***Install 2 ohm bus tie reactors at Kingsville TS, Longwood TS, Caledonia TS, Keith TS DESN 1 and Clarke TS***  
***Notification of Conditional Approval of Connection Proposal***  
***CAA ID Number: 2011-EX540***

**Final Report - Expedited System Impact Assessment**  
**Hydro One Networks Inc.**

**Install 2 ohm bus tie reactors at Kingsville TS, Longwood TS, Caledonia TS, Keith TS DESN 1, Clarke TS and Hamilton Nebo TS DESN 1**  
**CAA ID# 2011-EX540**

**Figure 1 – Typical Bus Tie Reactor Configuration for 4 Transformer station**

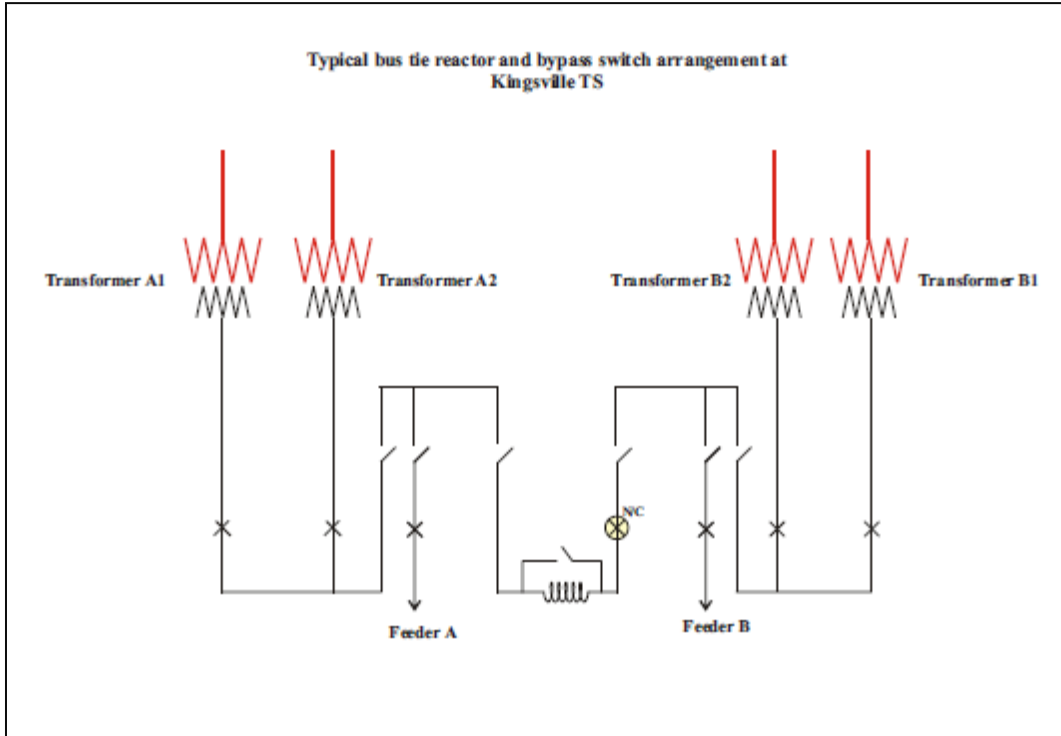
The bus tie reactor by-pass switches at Longwood TS, Caledonia TS, Keith TS DESN and Clark TS will be closed automatically in less than 10 cycles when one of the 2 transformer breakers opens. The bus tie reactor by-pass switch at Kingsville TS will be closed automatically in less than 10 cycles when two or more of the 4 transformer breakers opens.

The voltage drops across the bus tie reactors during a contingency of the loss of one transformer breaker (2 breakers at Kingsville) must be taken into account by the LDCs.
